ECE/TRANS/WP.29/2006/26
19 December 2005

PROPOSAL FOR THE 02 SERIES OF AMENDMENTS TO REGULATION No. 107

(M₂ and M₃ vehicles)

Transmitted by the Working Party on General Safety Provisions (GRSG)

"Figure 1

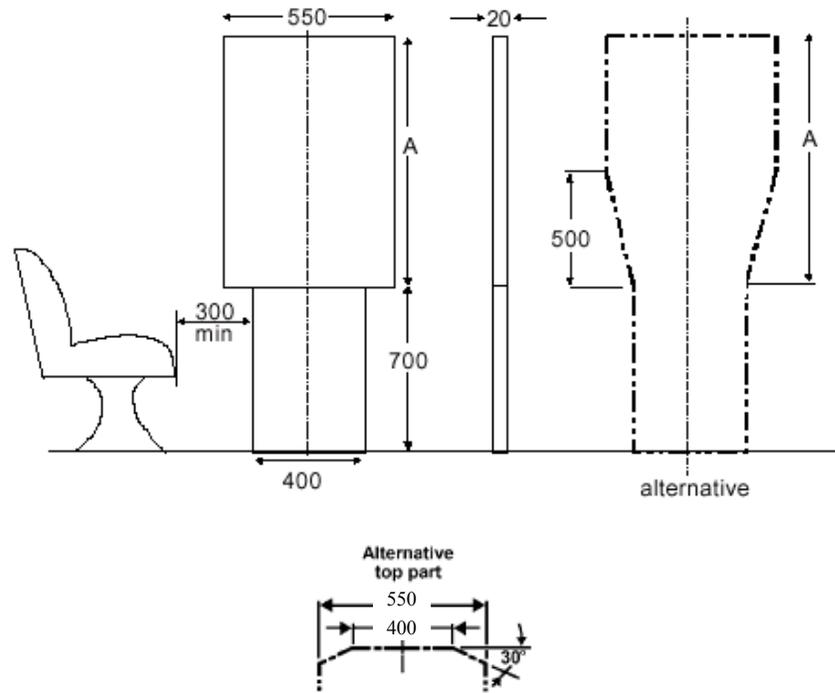
Figure 1, and the text below, amend to read:

ACCESS TO SERVICE DOORS

Classes I, II and III: A = 1,100 mm

Classes A and B: A = 950 mm

Number of passengers	≤ 22 ^{1/}		> 22		
Classes	A	B	I	II	III
Dimension A (mm)	950	700	1,100	950	850
Total height of dual panel	1,650	1,400	1,800	1,650	1,550

"Figure 5

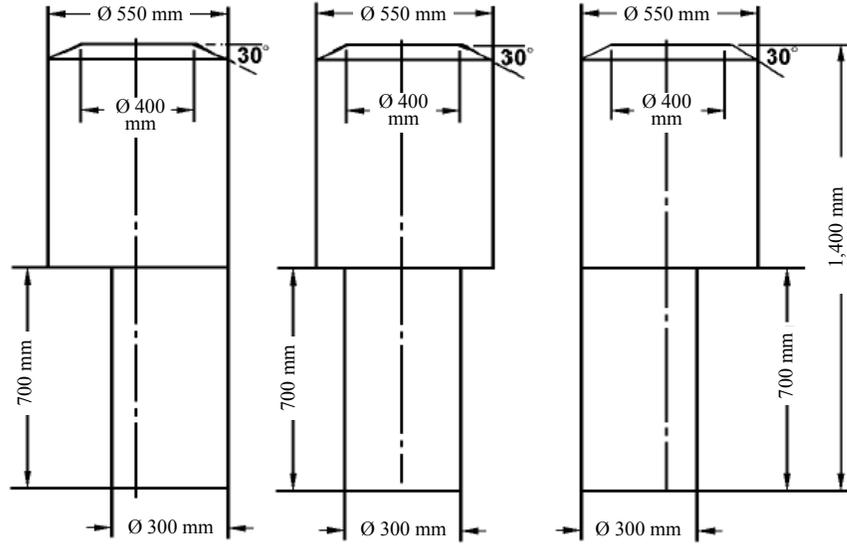
Figure 5, amend to read:

ACCESS TO EMERGENCY DOORS

"Figure 6

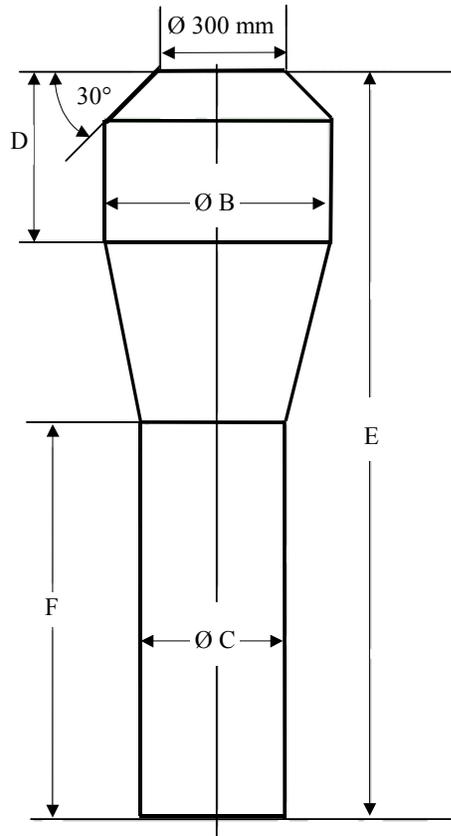
Figure 6, and the text below, amend to read:

GANGWAYS

Single deck						
Class		B (mm)	C (mm)	D (mm)	E (mm)	F (mm)
A		550	350	500 <u>4</u> /	1,900 <u>4</u> /	900
B		450	300	300	1,500	900
I		550	450 <u>3</u> /	500 <u>4</u> /	1,900 <u>4</u> /	900
II		550	350	500 <u>4</u> /	1,900 <u>4</u> /	900
III		450	300 <u>2</u> /	500 <u>4</u> /	1,900 <u>4</u> /	900
Double deck						
I	LD	550	450 <u>3</u> /	500	1,800 <u>1</u> /	1,020 <u>1</u> /
	UD	550	450 <u>3</u> /	500	1,680	900
II	LD	550	350	500	1,800 <u>1</u> /	1,020 <u>1</u> /
	UD	550	350	500	1,680	900
III	LD	450	300 <u>2</u> /	500	1,800 <u>1</u> /	1,020 <u>1</u> /
	UD	450	300 <u>2</u> /	500	1,800	900

- 1/ The overall height of the gauging device may be reduced (by reducing the height of the lower cylinder):
- (a) from 1,800 mm to 1,680 mm in any part of the gangway of the lower deck to the rear of a transverse vertical plane situated 1,500 mm forward to the centre of the rear axle (foremost rear axle in the case of vehicles with more than one rear axle),

- 2/ 220 mm in the case of laterally movable seats (see paragraph 7.7.5.3).
- 3/ The diameter of the lower cylinder may be reduced from 450 mm to 400 mm in any part of the gangway to the rear of the most forward of the following two planes:

- 4/ The height of the upper cylinder and herewith the overall height may be reduced by 100 mm in any part of the gangway to the rear of:
- (a) a transverse plane situated 1.5 m forward of the centre line of the rear axle (foremost rear axle in the case of vehicles with more than one rear axle), and
 - (b) a transverse vertical plane situated at the rear edge of the service door or of the rearmost service door if there are more than one service door."

"Figure 8

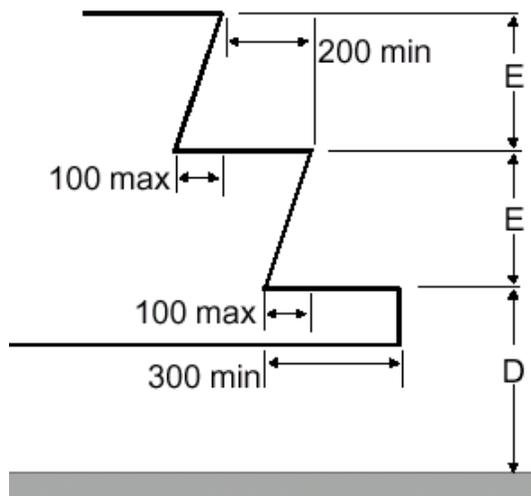
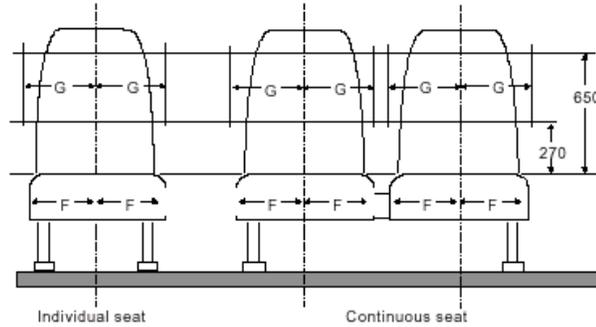
Figure 8, and the text below, amend to read:

STEPS FOR PASSENGERS

Classes		I and A	II, III and B
First step from ground "D"	Max. height (mm)	340 <u>1/</u>	380 <u>1/ 2/ 5/</u>
	Min. depth (mm)	300 <u>*/</u>	
Other steps "E"	Max. height (mm)	250 <u>3/</u>	350 <u>4/</u>
	Min. height (mm)	120	
	Min. depth (mm)	200

1/ 700 mm in the case of an emergency door.

2/ 430 mm in the case of a vehicle with solely mechanical suspension.

Note: 1. At a double doorway the steps in each half of the access passage shall be treated separately.

2. "E" need not be the same for each step."

Figure 9A

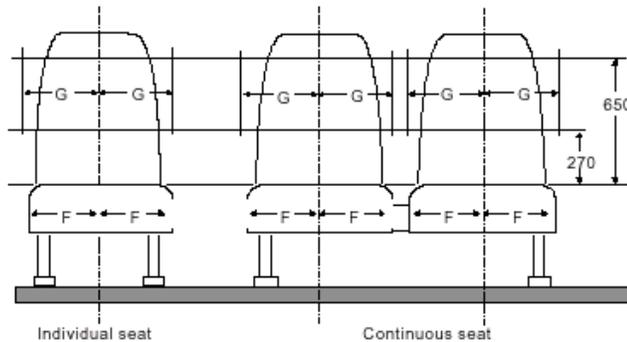
Figures 9 and 9A and the tables below, amend to read:

WIDTH OF PASSENGER SEATS

F (mm) min	G (mm) min	
	Continuous seats	Individual seats
200	200	200

"Figure 15

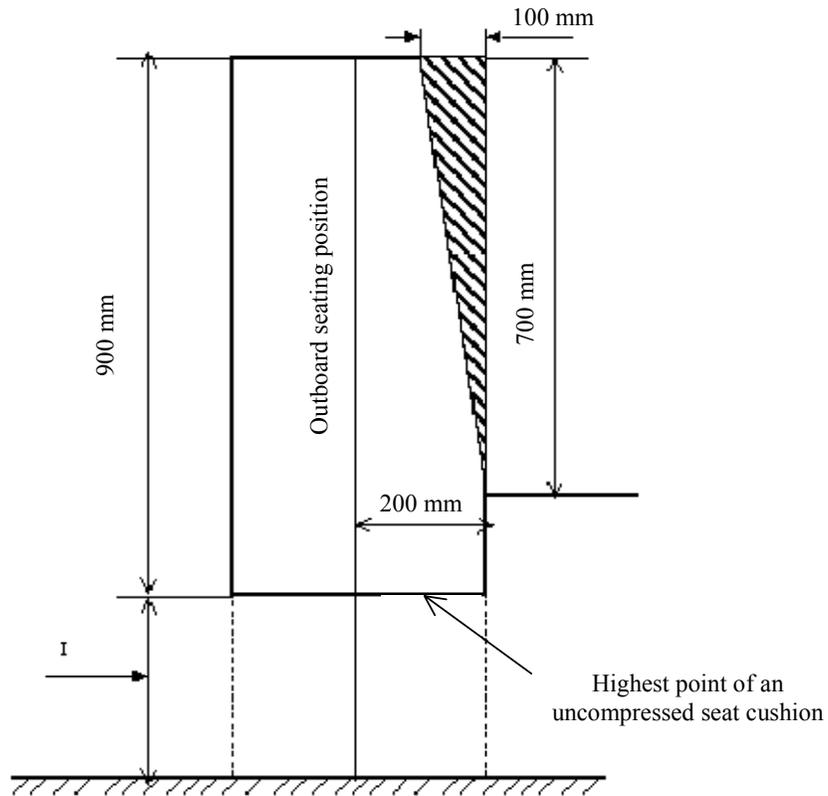
Figure 15, amend the figure and insert a table to read:

PERMITTED INTRUSION ABOVE A SEATING POSITION

I (mm)
400 to 500
(for classes A, B, I and II min 350 mm at wheel arches and engine compartment(s))

"Figure 20

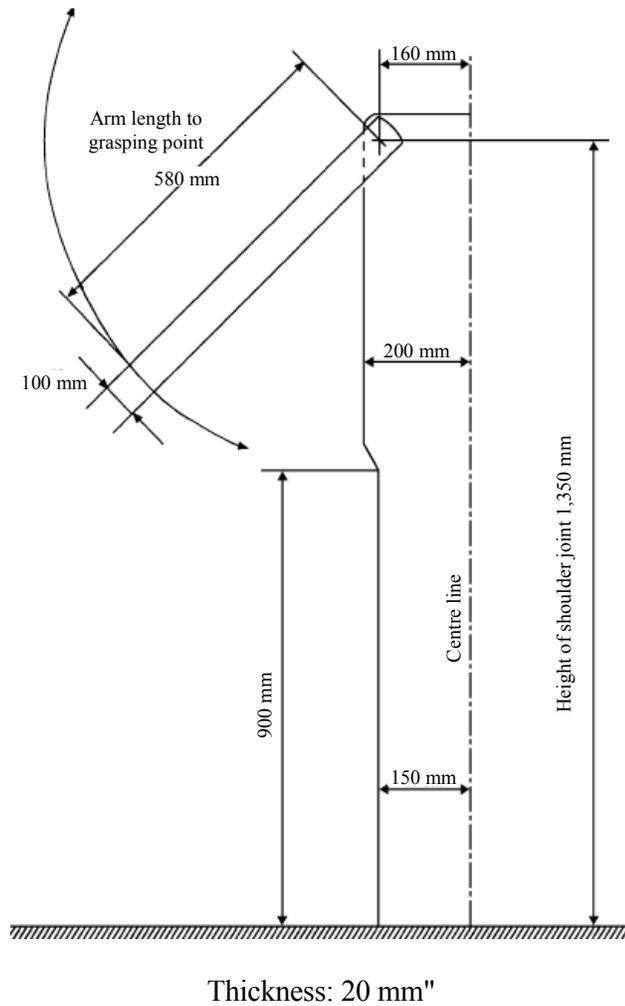
Figure 20, amend to read:

TESTING DEVICE FOR SITING OF HANDHOLDS

"Figure 24

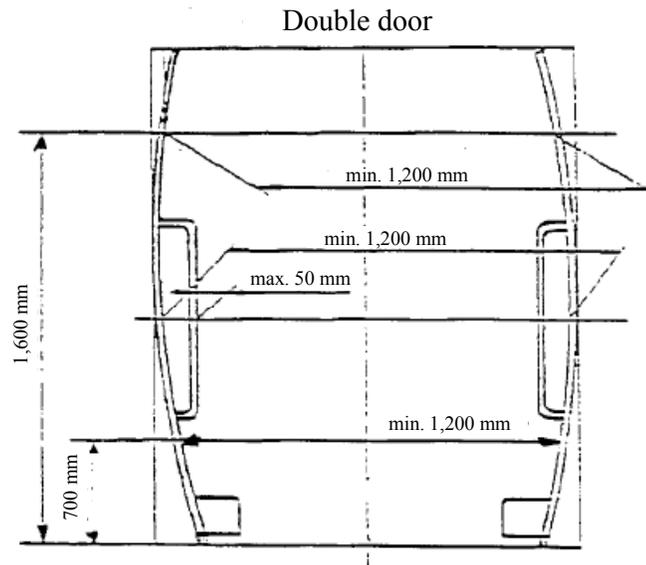
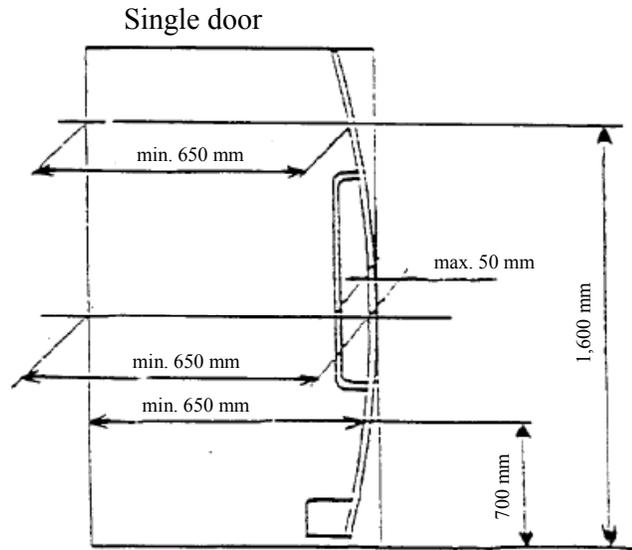
Insert new figures 24 to 26, to read:

"7.6.3.1. The several kinds of exit shall have the following minimum dimensions of free access (see also Annex 4, figure 24):

SERVICE DOOR FREE ACCESS
